COMMUNITY DESIGN INPUT WORKSHOP FOR THE BROOKLYN FACILITY

January 23, 2024

Brooklyn Borough Based Jail

BBJBK DESIGN WORKSHOP #2 COMMUNITY COMMENTS

WHAT WE HEARD - INTERIOR SPACE

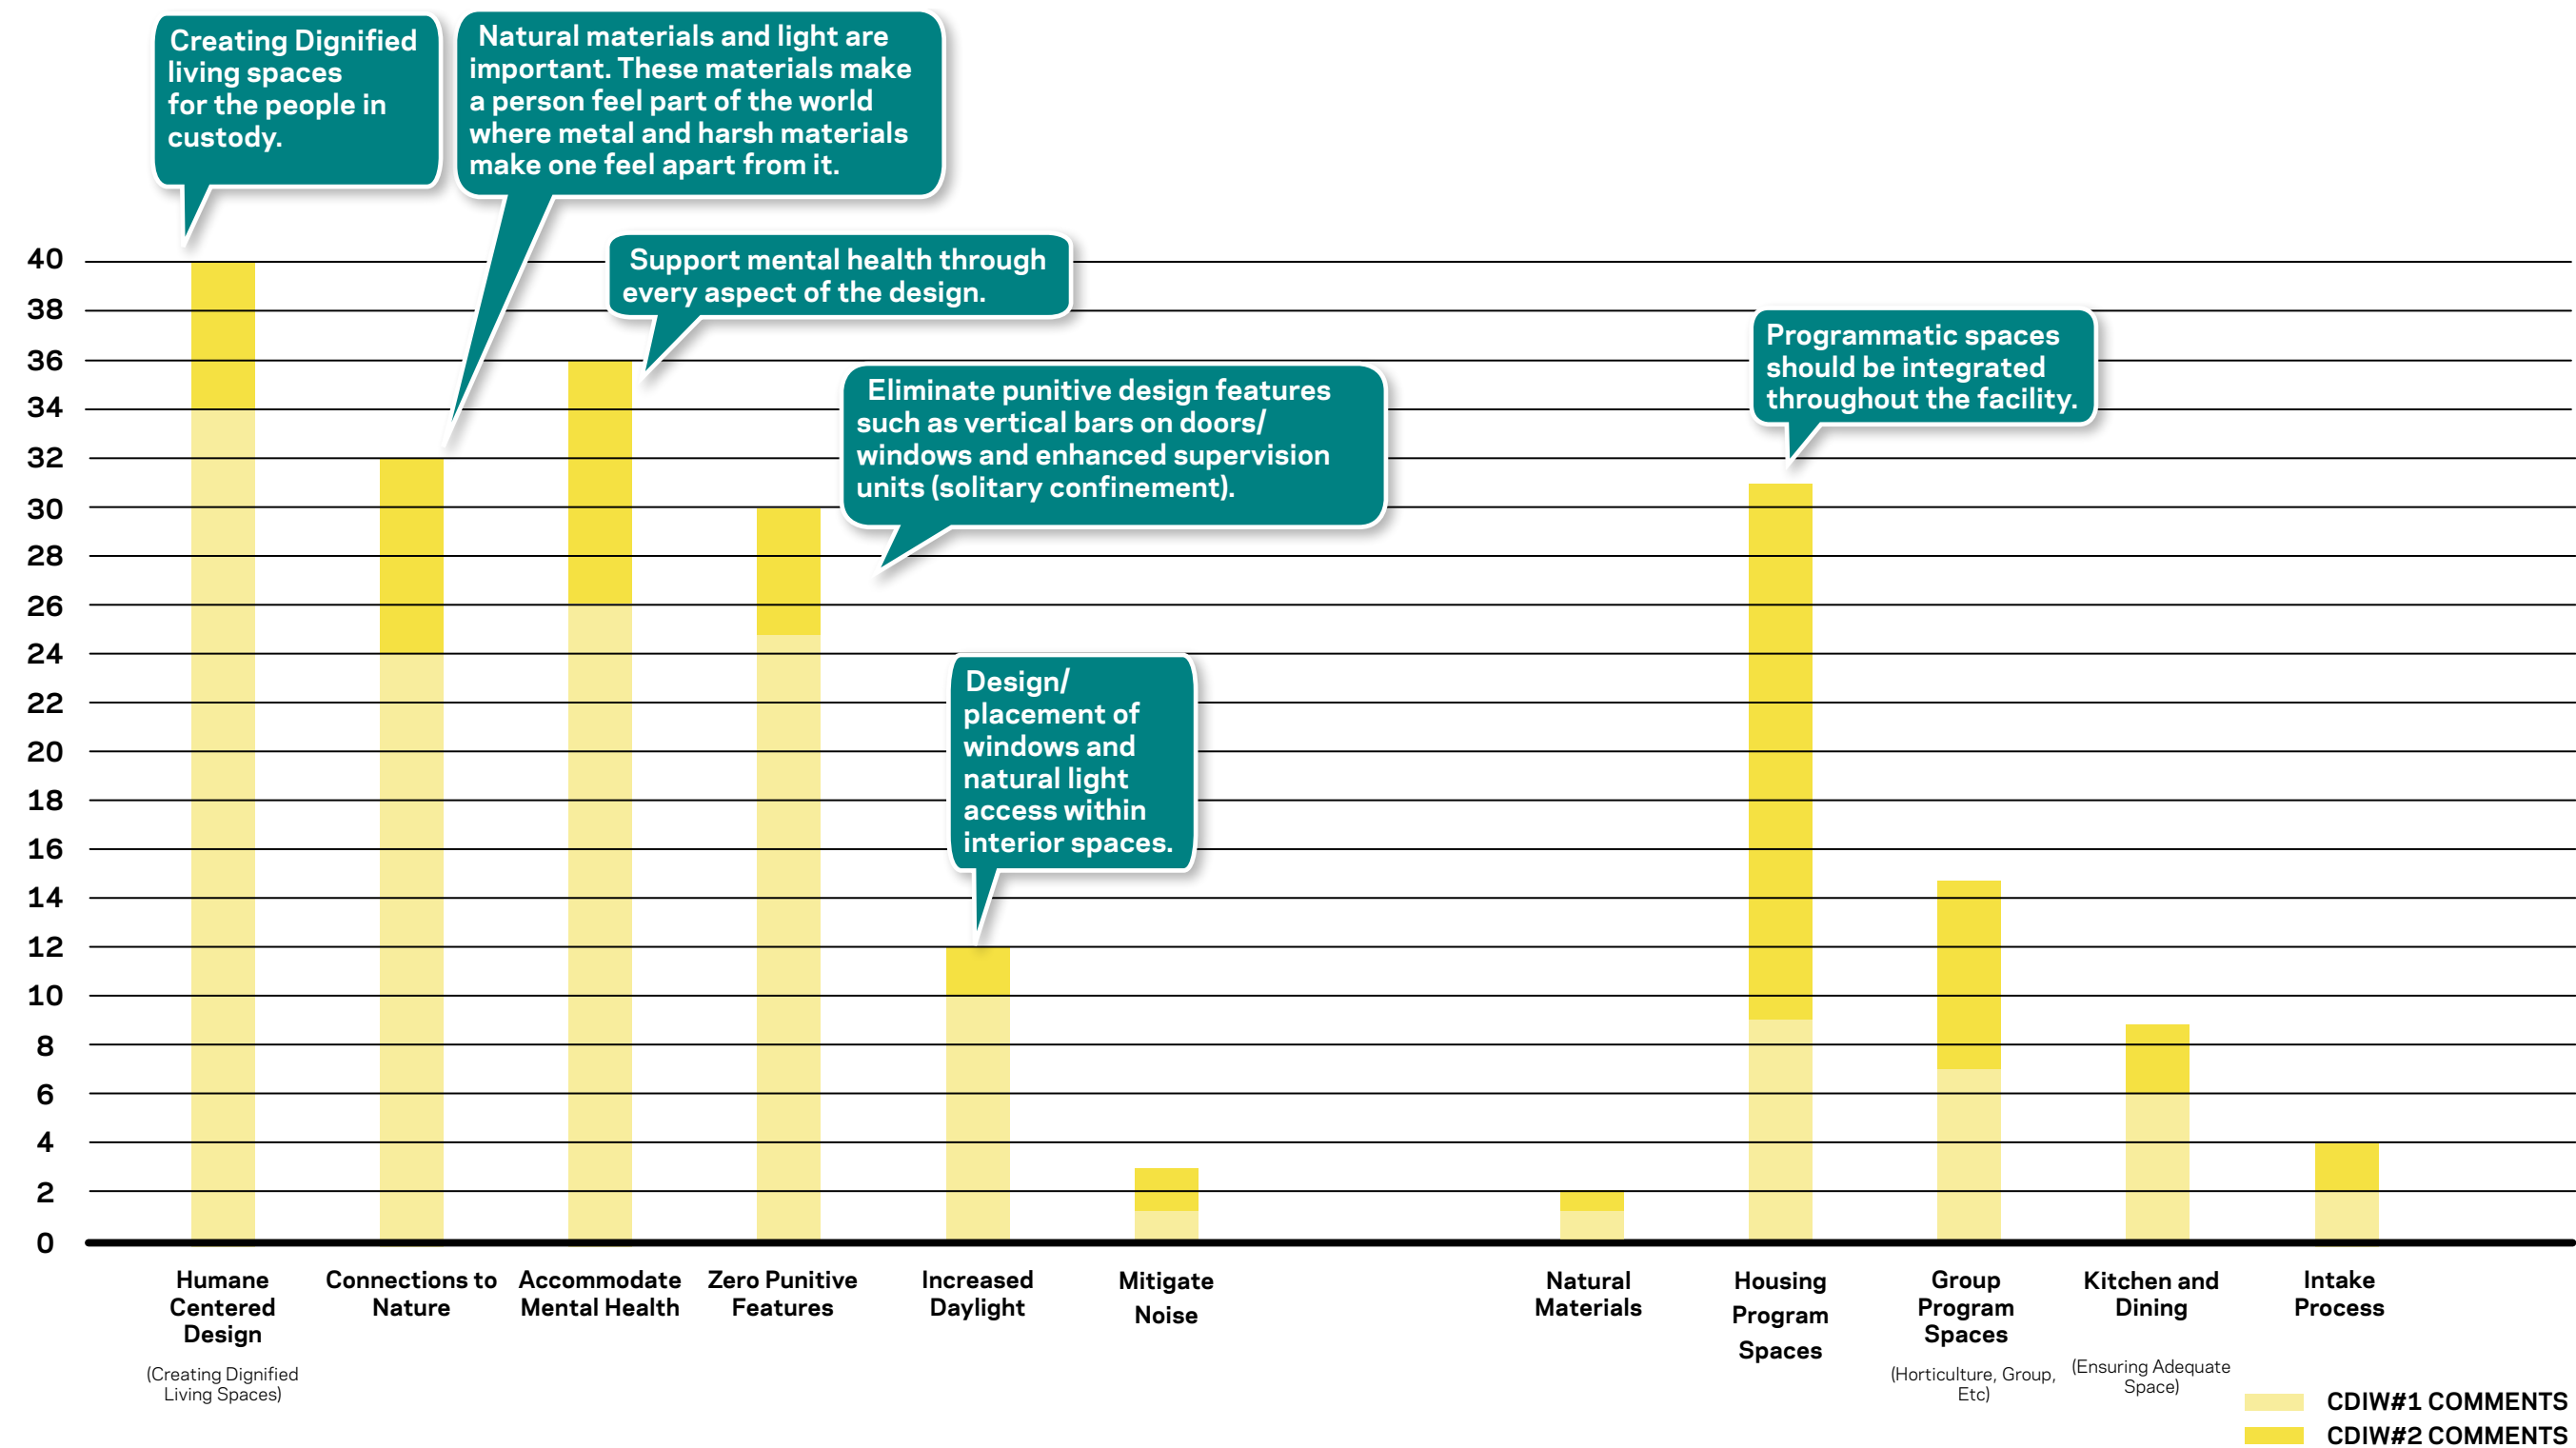
COMMENT	RESPONSE
INTERIOR SPACE	
Where is the horticulture program?	The horticultural program is located on one of the roof quads.
Thank you for being thoughtful in your consideration of surrounding neighbors' privacy.	Thank you!
All housing units are currently designed to be single cell which is great for privacy and security reasons but the designs should include at least two dormitory style housing units. Dorms should be included as an option for incarcerated individuals who have chronic health concerns or mental health concerns.	All housing will be in single cells to foster a sense of privacy and security. Use of light, windows, normalized furnishings, and other strategies are being utilized to create a humane environment and improve the well-being of people in custody.
I was on Rikers; institutional colors (green) have to change because they activate those memories/negative experiences.	Color selections are being reviewed. The intent of the color is to providing a calming and therapeutic environment for the occupants.

Dark blue is also an institutional color, pink as well.	Color selections are being reviewed. The intent of the color is to providing a calming and therapeutic environment for the occupants.
Is the top open? To the air?	The horticulture program will be open to the air but does include a security mesh.
Implications of the 10/18 CB meeting being so close, how will we incorporate interior changes?	Interior spaces will be shared with the community in Workshop #3. There will be additional meetings with Community Board 2 and the Public Design Commission as the design develops.
How large is horticulture space?	The size of the horticulture space is approximately 1400 square feet.
Timeline for shutting down Rikers?	Mayor Adams supports closing Rikers Island under a plan that ensures the dignity, safety, and care for all justice-involved New Yorkers. It is important to mention that the COVID-19 pandemic had wide-ranging impacts on the criminal justice system and jail system in New York City — disrupting court operations, increasing the time to trial, and extending the length of stay for persons in custody — all of which has led to a substantial increase in the jail population on Rikers Island. The pandemic also caused significant issues and delays with the previous administration's plans to issue requests for proposals and implement the design-phase of the borough-based jails plan, as well as brought construction projects to a halt while causing costs to skyrocket. That is why the Mayor was encouraged to see the Independent Commission on Criminal Justice and Incarceration Reform be reconvened, recognizing the need to reassess the current plan and offering to help develop new recommendations for how New York City can best move forward to close Rikers Island. This administration's commitment to the success of our jail system is unwavering, but we also have taken stock of the reality of how this once-in-a-generation pandemic impacted the original timeline for the implementation of the borough-based jail plan. The answer is not to ignore reality or compromise public safety, but to work together to find solutions.

No live greenery in housing, biophilia will be incorporated into housing.	Live plantings can not be provided in interior spaces. Biophilic colors and art are being studied.
Are you dimensioning number of double stack housing units?	Yes, they will be dimensioned.
How do the double tier units work?	The double tier units have single cells on two levels, connected by two stairwells.
Horticulture space is for 80 people?	The size of the horticulture space is approximately 1400 square feet and can fit up to 36 people.
Where is the security control center?	The security control center is located within the secure perimeter of the Facility.
Other than the horticulture, are there any other large outdoor spaces?	Outdoor recreation areas with natural ventilation are provided for all housing units. Staff Dining will also have an outdoor dining area which will be open to air and views.

COMMENT	RESPONSE
This recreational space is not what I would describe as an outdoor space; are there any ways we can consider access to the environment (like an occupied roof?)	The rooftop is occupied by a 1400 square foot horticulture program, as well as mechanical equipment and other building functions. There are outdoor recreation areas in each housing unit that provide access to the elements.
Recreational space does have fresh air, but it isn't completely open.	Recreation areas are open on two sides and are provided at every housing unit.
If you had single tiers, how many people? Is there any way to reduce the number of double units? From a CO perspective, there are many safety concerns because you cannot see what's happening.	All housing will be in single cells to foster a sense of privacy and security. Required bed count and site constraints require that some number of units be configured as two-tiered. The team is developing designs that will make these spaces as safe, normalized and humane as possible. We will use the additional height in the space to provide enhanced daylighting into the unit.

The point of this facility is to reduce the jailed population, are there any considerations for alternative use?	The civic design of the building may allow for alternative uses in the future based on the City's assessment of needs and resources.
From the ULURP process; its difficult to reutilize this type of facility	The civic design of the building may allow for alternative uses in the future based on the City's assessment of needs and resources.
What other jails have you designed? Is it on your website?	Our team has designed several similar facilities, particularly in the last ten years. Many examples are on our web site at https://www.hok.com/projects/market/justice/
There were only a few double tier illustrated, is the 60% a response to an increase in beds?	All housing will be in single cells to foster a sense of privacy and security. Required bed count and site constraints require that some number of units be configured as two-tiered. The team is developing designs that will make these spaces as safe, normalized and humane as possible. We will use the additional height in the space to provide enhanced daylighting into the unit.

Can you describe the actual conditions inside the cell?	All cells will be single occupancy and include a separate sink and toilet. Cells will be furnished with a bed, a desk, a shelf, and storage bins. All cells include a light over the bed and desk to all the occupants to control lighting in their cell. All cells have a window facing the exterior of the building.
The shower areas, what are those like?	Showers, including those that are ADA-compliant, are provided in all housing units. Each shower has a dressing/drying area just outside the shower itself. Shower doors provide a balance between privacy and security.
In terms of the interior cell spaces, do you have individual lighting and ventilation controls?	Yes
This time we are seeing less images of the interior than before Why? Isn't that part of the feedback process?	Interior views will be shared in Workshop #3.
We would like to see how the living quarters are actually made up.	Interior views will be shared in Workshop #3.

For people with SMI or autism, will there be ability to control blankets, sheets, food plating for those with sensitivities?	The Facility will have internal spaces with neurodiversity in mind. This includes providing different seating options, lighting strategies that create a calming glow, purposely placed artwork for moments of distraction/respite, varying textures, and warming earth tones as an overall base material palate.
Some dormitories should be included in the design. People who are claustrophobic and transitioning back into the communities should have access to open space housing.	All housing will be in single cells to foster a sense of privacy and security. Use of light, windows, normalized furnishings, and other strategies are being utilized to mitigate issues of claustrophobia.

COMMENT	RESPONSE
It is important that this building be distinguished by its attractive exterior. However the quality of its interior will be the true addition to our community. The humane and regenerative quality of the space and care and programs for those living and working within is what will add to our community. I heard at the meeting that the facility would have programs and medical facilities like those at Rikers and know this is not adequate. There should be light in each cell. There should be fresh air spaces. As much as possible there should be garden elements. Cells should have space for personal belongings such as shelves. Pictures of the best prisons I have seen include outside enclosed, internal yards. There should be access to exercise and education and art programs and job training. There should be work available in kitchen, gym, garden. Solitary confinement should not exist. There should be adequate counselors and medical and mental health facilities. There should be enough corrections officers to make the jail experience as positive as possible so that the incarcerated reenter society with skills and hope, having been treated with dignity and interacted positively. The spaces for staff should also be elevated.	The facility design is based in principles of dignity, respect and rehabilitation. The facility will include programming for education, vocational training, counselling and horticulture. All cells will be single occupancy and include a separate sink and toilet. Cells will be furnished with a bed, a desk, a shelf, and storage bins. All cells include a light over the bed and desk to all the occupants to control lighting in their cell. All cells have a window facing the exterior of the building. All housing units include access to mental and medical health care providers. Every floor will include space for treatment in addition to the main clinic. The rooftop is occupied by a 1400 square foot horticulture program. There are outdoor recreation areas in each housing unit that provide access to the elements. The design team is looking to introduce biophilic elements and warm color palates to promote a calming and dignified environment. Please visit our website for more information about the City's vision and goals for the Borough-Based Jails Program: https://rikers.cityofnewyork.us/

Swedish prison cells are particularly good examples and make one aware that natural materials and light are important. These materials make a person feel part of the world where metal and harsh materials make one feel apart from it.	The design team is looking to introduce biophilic elements and warm color palates to promote a calming and dignified environment. Everyone housing cell will have access to natural light through a window facing the exterior of the building. Additionally, all cells include a light over the bed and desk to all the occupants to control lighting in their cell.
Important to make sure that families can visit in a humane way, that children can interact with their parents.	Contact visiting is designed with family visits in mind. The design includes children's play areas in both the lobby and visiting areas, as well as areas designed for older children.
It is important that nutrition be considered to build a healthy lifestyle. Food available at commissary should also contain variety of fresh options.	We are working with the Mayors Office of Food Policy to ensure nutrition is considered in food service programs. Food is prepared in a central kitchen and all dining takes place within the living units. Meals are delivered to each housing unit by cart. Seating is provided in the dayroom for dining.

I have seen posted that we need to have at least 40% of the space for therapeutic spaces for the mentally ill. This is probably not even adequate. This is one of the most crucial pieces to get right. A separate facility would probably be warranted. It seems that for programs to be effective, they would have to be geared to mentally ill and those who are not. This would require a big programming effort which would be great to see in detail.	All housing units include access to mental and medical health care providers. Every housing floor will include space for treatment in addition to the main clinic. The Lippman Commission 2.0 is also evaluating this issue.
Making sure there is space for the right number of corrections officers is important. At Rikers there are not even enough corrections officers to bring clients to meetings with their lawyers. Lawyers wait a couple hours and leave without seeing the person they are defending. This cannot continue to be the case. Having the right numbers of officers should make for a more respectful attitude.	The siting of the Borough-Based Jails allows for people in custody to be housed in their communities for improved access to lawyers, family and friends and more efficient operations for DOC. DOC is currently hiring for more Correction Officers. Please share this link with anyone interested in applying: https://www.nyc.gov/assets/dcas/downloads/pdf/noes/20244301000.pdf

Designs should include at least two dormitory style housing units should be included as an option for incarcerated individuals who have chronic health concerns or mental health concerns (I.e., seizures, claustrophobia)	All housing will be in single cells to foster a sense of privacy and security. Use of light, windows, normalized furnishings, and other strategies are being utilized to mitigate issues of claustrophobia. The design is being coordinated with medical and management staff to ensure no hinderance to getting medical responses.
A truly therapeutic environment must maximize connection and minimize isolation. That includes maximizing window sizes and eliminating bars on windows. There should be no consideration for making windows smaller.	One of the goals of the BBJ Program has always been that every housing cell has access to natural light through a window to the building exterior. The size of the window significant exceeds the minimum 8 square foot window required by law. Additionally, the cells are intended to promote a normative environment. For instance, all cells include a light over the bed and desk to all the occupants to control lighting in their cell.

COMMENT	RESPONSE
there should be no showers in locked spaces - these can and have been inappropriately used for isolation and have had deadly results. Additionally, ESH units (Enhanced Supervision Housing). This is the term DOC uses for solitary confinement, Decontamination showers. These are showers with cages around them, which are used as informal solitary confinement and create a particular risk for suicide Double-tier units - which have a mezzanine level with a railing - especially in therapeutic housing. A person died in a mental health housing unit earlier this year by jumping or falling from the mezzanine. Bars of any type! “Bubble” which officers sit in. ESU spaces (Emergency Services Units). These units operate as a riot squad for the jails, and a federal monitor has said they are overused and often escalate violence instead of stemming it.	The City does not practice solitary confinement in accordance with the HALT Act. The Facility is being designed to create a therapeutic environment. All furnishings within the Facility are being designed to prevent individuals from self-harm or suicide by reducing or removing the possibility of individuals using ligatures to inflict self harm. Showers, including those that are ADA-compliant, are provided in all housing units. Each shower has a dressing/drying area just outside the shower itself. Shower doors provide a balance between privacy and security.
